**CITY OF KLAMATH FALLS  
PLANNING COMMISSION**

**Staff Report  
16-DR-10**

**August 23, 2010**

Request for approval to develop a residential facility to provide care for up to 12 residents on a 6,000 sq ft lot zoned Medium Density Residential (MD)

# Site Plan (No Scale)

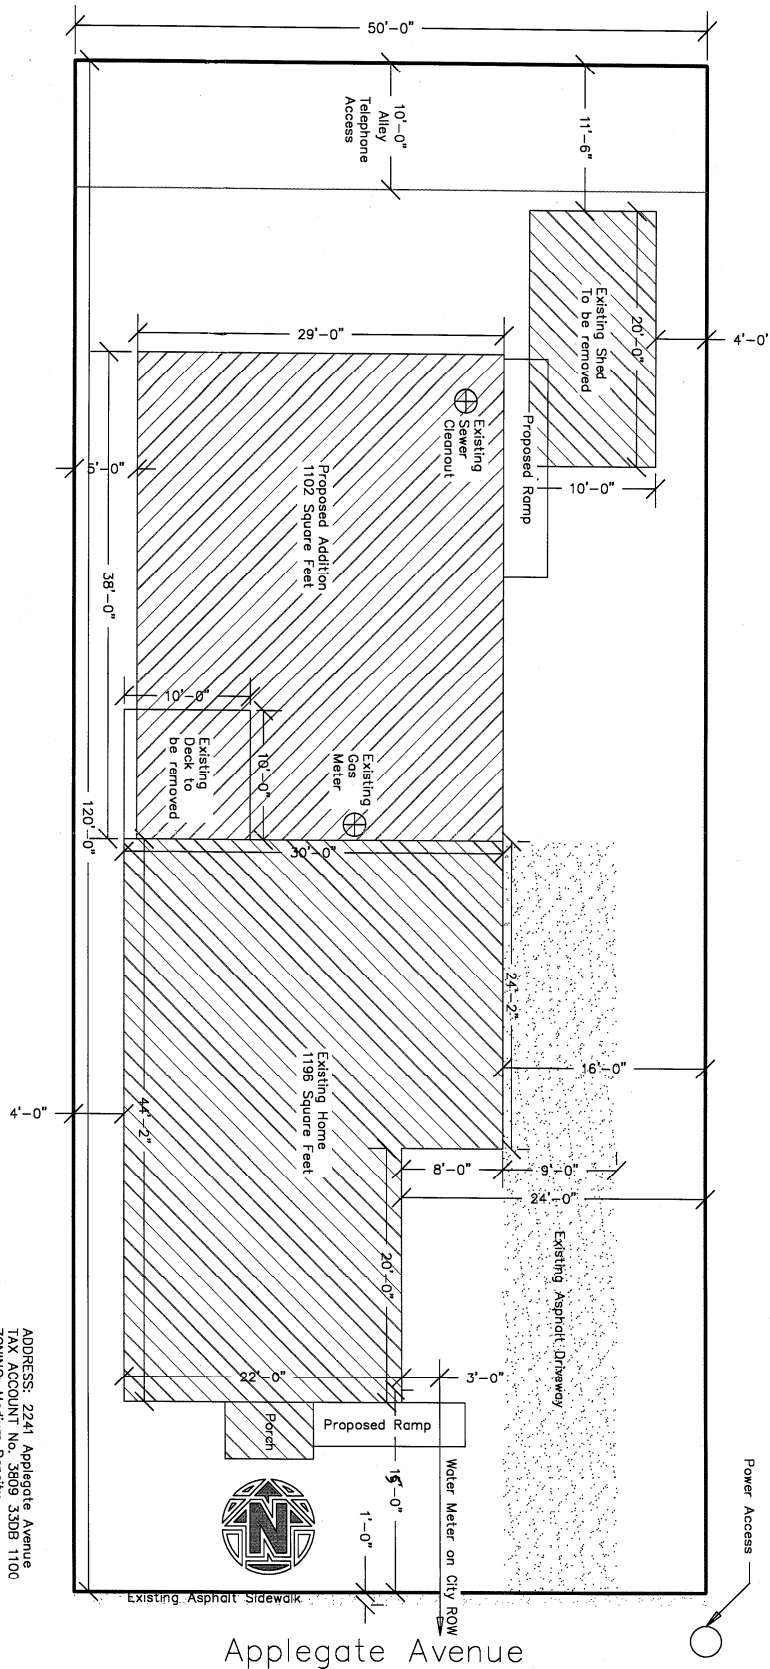
1. Lot Coverage: Community Development Ordinance (CDO) Section 12.010 allows for a maximum lot coverage of 40% for Medium Density zones. The subject property is 6,000 sq ft in size (50' x 120'). The existing home is approximately 1,196 sq ft, and the proposed addition is approximately 1,102 sq ft (plus 100 sq ft for wheelchair ramps); for a total building area of 2,398 sq ft. The existing 200 sq ft (20' x 10') shed will be removed as part of this proposal. The resulting lot coverage will be 40%.

2. Setbacks: Medium Density zoning allows for the following minimum setback distances: 20' front yard, 10' exterior side yard, 5' rear yard, and 5' interior side yard. The existing house and shed have the following setback distances: Approximately 10.5' front (south) (to the front porch), approximately 4' interior side yard (west), approximately 4' interior side yard (east), and approximately 11.5' rear yard (north). Once the shed is removed the east interior side yard setback will be increased to

approximately 16'. The building addition will be constructed approximately 5' from the west property line and approximately 23' from the rear (north) of the property resulting in the following final setback distances: Approximately 10.5' front (south) (to the existing front porch), approximately 4' interior side yard (west) (to the existing portion of the house), approximately 23' rear yard setback (north), and approximately 16' side yard setback (east). Both the front yard setback and the west side yard setback are below the minimums allowed by the CDO. Both of these setback distances are existing conditions and the nonconformity will not be increased or expanded through the proposed expansion.

3. Parking: CDO Section 14.010 requires 1 parking space for every 4 beds for Residential Facilities. The proposed facility will have a total of 12 beds requiring a total of 3 parking spaces. The proposed site plan shows an existing asphalt driveway but it does not show the location of the three required parking spaces.

4. Landscaping: CDO Section 14.410(3)(c) requires a minimum of 3% of the space provided for vehicular circulation to be landscaped and in no case shall there be less than 200 sq ft of landscaped area. The site is required to have a minimum of 200 sq ft of landscaping. A landscaping plan was not provide with this application.

5. Signs: The site plan does not show the placement of any new signs on the subject property. Approval of this Design Review does not constitute approval of sign

6. Fences: The site plan does not show the placement of any new fences on the subject property. Approval of this Design Review does not constitute approval of fence placement, materials, or height. *A fence permit shall be submitted, reviewed, and approved prior to installation of any fence.*

1. City water and sewer service: Overall the plans are incomplete for City Engineering to comment on City utility service and any associated System Development Charges (SDC's). The Engineering design/construction plans shall show the location of the existing water meter and indicate if there will be any request to upgrade (increase the size) the water meter. A Fire Hydrant Test Form was completed and submitted to the applicant for fire flow determination. The make and model of the proposed irrigation backflow is required as part of the design review to obtain City approval. The applicant has not submitted the Sewer System Development Charge Calculation Sheet to determine the SDC at this time. The design/construction plans shall show the location of the existing sewer service connection.

*The applicant shall submit a revised site plan showing the following details:*

- *3 parking spaces to be provided*
- *An accessible route from the parking area into the building*

*All required parking shall be provided on improved (concrete or asphalt paved) surfaces. All required parking lot improvements shall be completed prior to occupancy.*

*The applicant shall submit a detailed landscaping plan, for review and approval, showing the following details:*

- *A minimum of 200 sq ft of landscaping; and*
- *all areas devoted to landscaped space shall have a minimum of one tree and two shrubs with at least one tree and two shrubs provided for every 1,000 sq ft of the total landscaped area; and*
- *all landscaped areas not covered with trees or other vegetation shall be covered with bark mulch; and*
- *a minimum of 50% of the landscaping area shall be covered by vegetation; and*
- *all required trees will be a minimum of 2" caliper in size; and*
- *irrigation method; and*
- *the species names of all plants.*
